ORIGINATION FORM

Proposed Revisions to a Standard Plans Index (Please provide all information – Incomplete forms will be returned)

Contact Information: Date: April 2, 2018 Originator: Rick Jenkins Phone: (850) 414-4355 Email: Rick.Jenkins@dot.state.fl.us Summary of the changes: Updated and Reorganized Index. Added new Shandle Deleted Design Notes. Updated Note language.	Standard Plans: Index Number: 436-001 Sheet Number (s): All Index Title: Trench Drain eet for General Notes.
Commentary / Background: Index reorganized to declutter details. Appropri Manual, Drainage Design Guide, FDOT Design M Notes language updated to the current standard	
Other Affected Offices / Docume Yes No Other Standard Plans — FDOT Design Manual — Basis of Estimates Manual — Standard Specifications — Approved Product List — Construction — Maintenance —	ents: (Provide name of responsible personnel)
Yes N/A ✓ Redline Mark-ups Proposed Standard Plan Instructions (Support Documents Other Support Documents Implementation:	nail or hand deliver package to Derwood Sheppard) SPI)

FY 2019-20 STANDARD PLANS

436-001

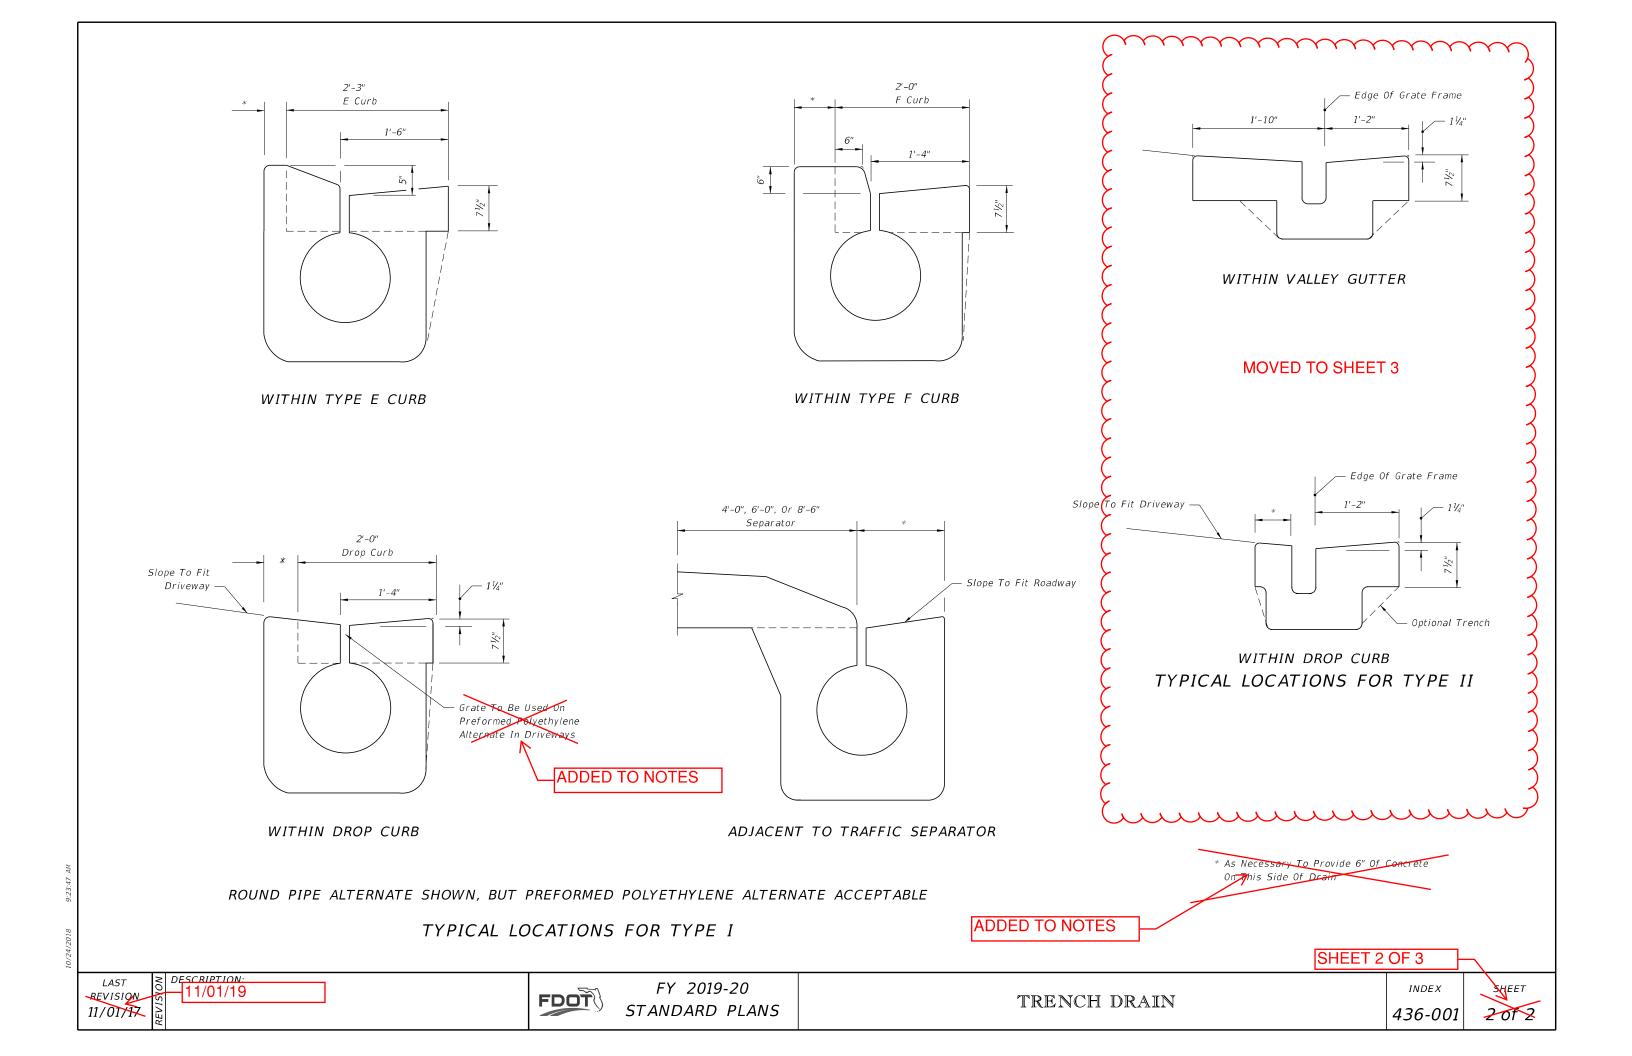
1. Trench drain is intended for use in gutters and driveways as shown on the typical locations on Sheet 2. Type I is intended for use in Type E, F and drop curbing, and adjacent to traffic separators and standard barrier walls. The width of the channel grate for Type I Trench Drain shall be 1¾" throughout varying the depth of the channel neck. Type II may also be used in those locations if an independent laboratory certifies that the grating used has an open area equal to at least 0.27 square feet per linear foot. Type II is primarily intended for use in valley gutter across driveway openings and drop curbing; Type I may also be used in those locations. The width of the channel grate for Type II Trench Drain shall be the same as the width of the channel. The linear slope or gradient for Type II may be manufactured by varying the depth of the channel. Trench Drain shall not be placed in pedestrian paths unless ADA compliant grates are used.

UPDATED NOTES

- 2. Unless shown in the plans, outlet pipes and preformed channel inverts shall be sloped 0.6% or steeper toward the outlet regardless of the surface slope.

- -3. Trench drain may be stubbed directly into drainage structures, or outlet pipes may be used to connect trench drain to drainage structures.
- 4. A cleanout port compatible with the manufactured system shall be provided for Type I drains at the upstream end and at intervals not to exceed 50 feet. The cleanout port shall provide an opening 6" to 10" wide (transverse to the trench drain length) and 18" to 24" long. Where cleanouts are placed adjacent to raised curb or separator, the curb or separator shall be formed around the cleanout. The cleanout shall have a removable load resistant cover or grate.

- Trench excavation must allow for a minimum of 6" of concrete to be placed under and alongside the trench drain channel system. Concrete حمد backfill shall meet the requirements of Section 347 of the Standard Specifications. At the end of all units (Type I or II), the concrete backfill shall extend 6" minimum past the end of the drain opening.

- 6. Transverse bars for Type I $\,$ Trench Drain shall be spaced 4" to 6" on center.

DESIGN NOTES MOVED TO DRAINAGE

- Number e placed adjacent MANUAL, DRAINAGE DESIGN II detail in the placs the position of the GUIDE, FDOT DESIGN foundation. (See Index MANUAL.
- 2. The designer shall identify the following in the plans:
 - (a) The type of Wain at each location.
 - (b) The begin and end locations of the Trench Drain.
 - (c) The location of the outlet pipe if the Trench Drain is not stubbed directly into a drainage structure.
 - (d) The design flow (Q) for the Trench Drain must be shown on the plans.
- 3. Capture efficiency for Type I Trench Drain may be computed using the equations for slotted drain in FHWA's HEC 12 & 22. Grate Type I and Type II must have at least 30% open area.
- 4. Round pine alternate is available in 12, 18, 24 and 36 inch.
- Type II Preformed Channel with integral anchoring lugs are applicable

- 1. Install outlet pipes and preformed channel inverts with a slope of 0.6% or steeper toward the outlet regardless of the surface slope, unless shown different in the Plans.

- 2. Stub trench drain directly into drainage structures or install outlet pipes to connect trench drain to drainage structures.
- 3. Provide a cleanout port compatible with the manufactured system for Type I drains at the upstream end and at intervals of 50 feet maximum. Provide a cleanout port with an opening of 6" to 10" wide (transverse to the trench drain length) and 18" to 24" long. Form curbs or separators around the cleanout when cleanouts are placed adjacent to raised curb or separator. Install the cleanout with a removable load resistant cover or grate.

- 4. Excavate trench to allow for a minimum of 6" of concrete to be placed under and alongside the trench drain channel system. Install concrete backfill in accordance with Specification 347. Install concrete backfill extending a minimum of 6" past the end of the drain opening at the end of all Type I or II units.

- 5. Install transverse bars spaced 4" to 6" on center for Type I Trench Drain.

TYPE I - NONREMOVABLE GRATE

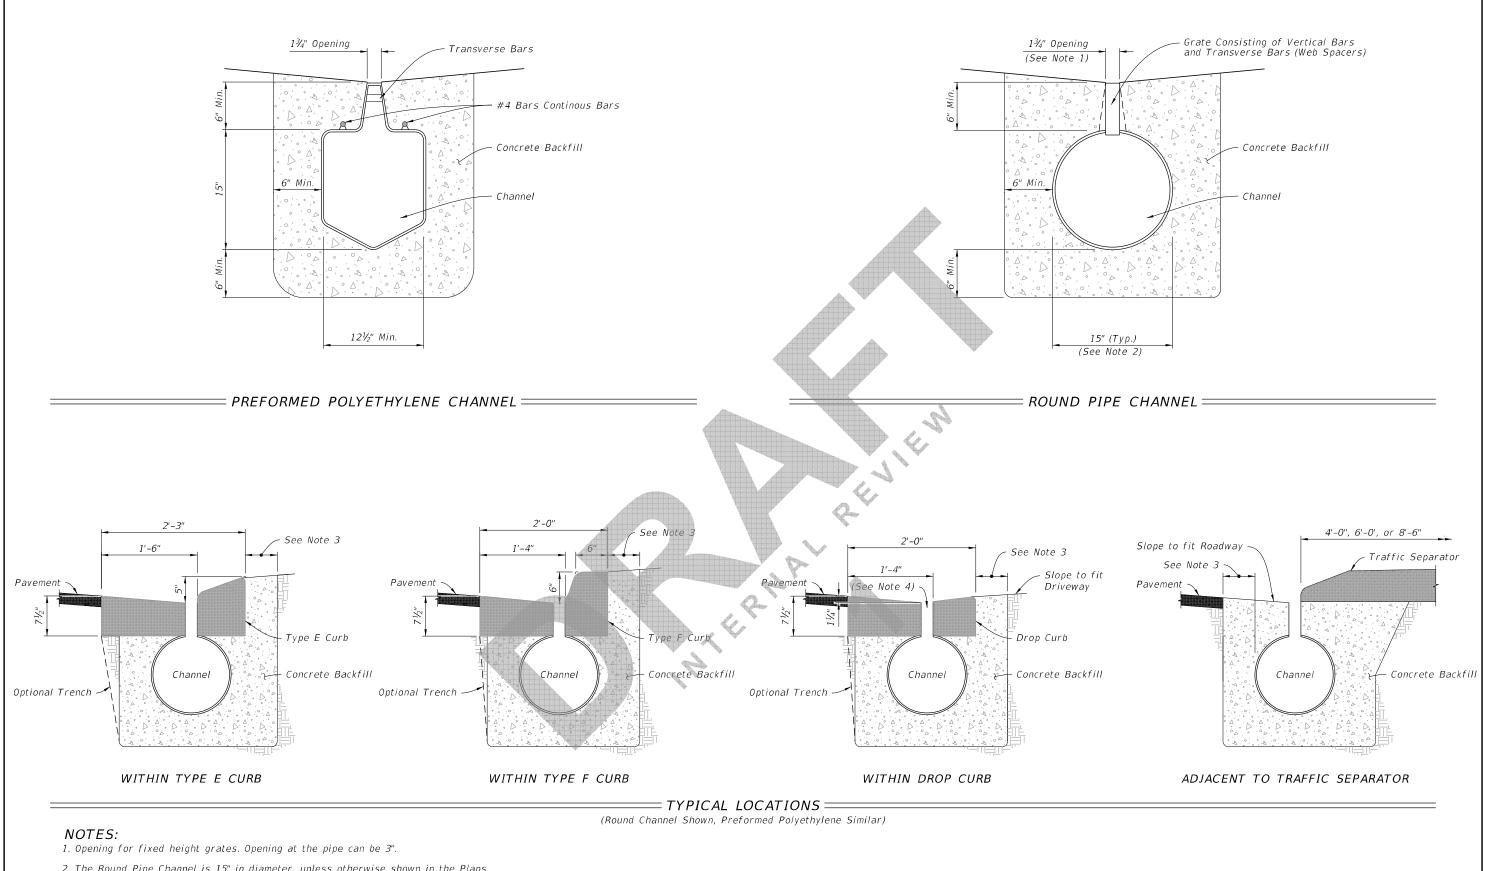
- 2. The Round Pipe Channel is 15" in diameter, unless otherwise shown in the Plans.
- 3. Provide a minimum 6" concrete on this side of the drain.

4. Install grates on preformed polyethylene channel at driveways.

TYPE II - REMOVABLE GRATE

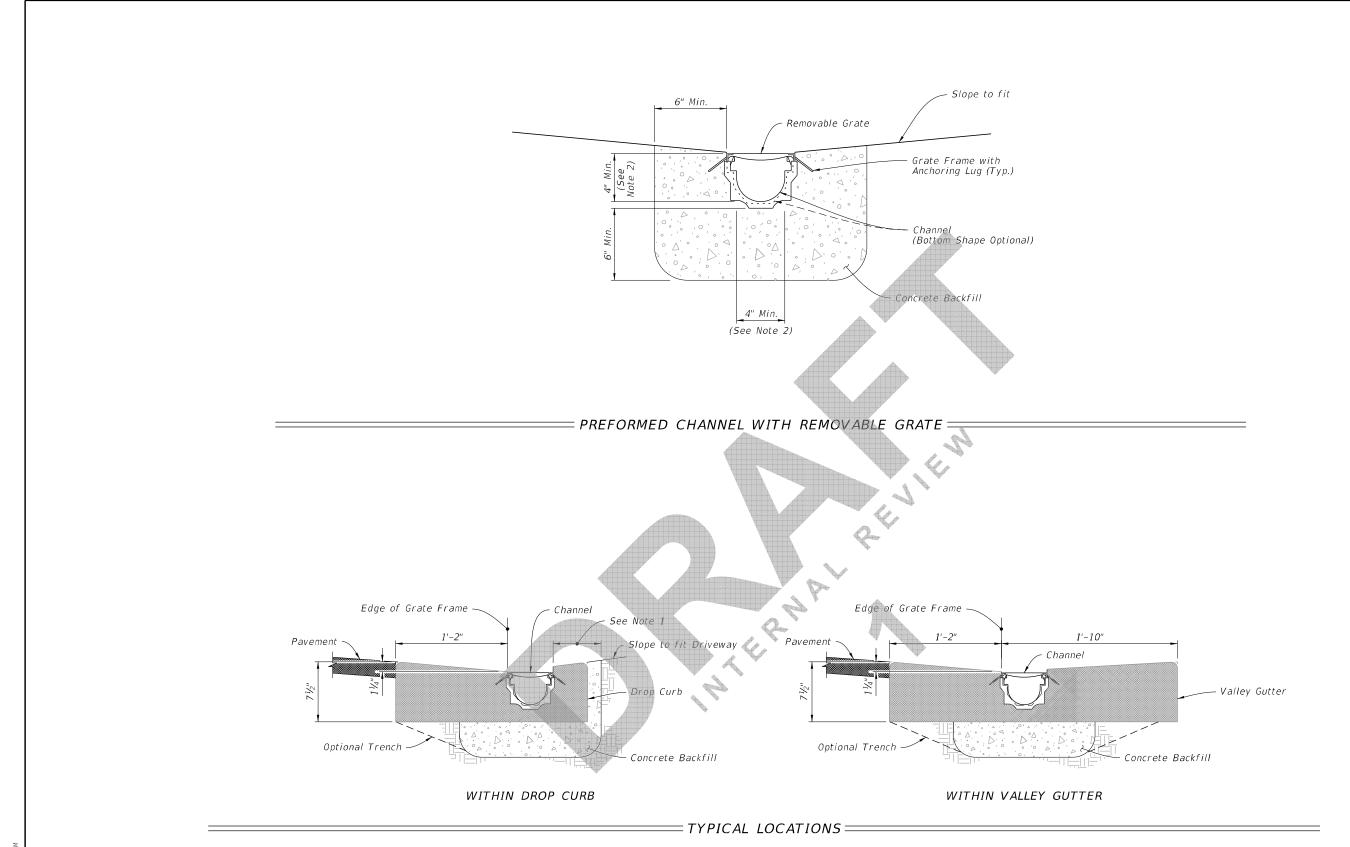
- 1. Provide minimum 6" of concrete on this side of the drain.
- 2. 4" Minimum unless otherwise shown in Plans.
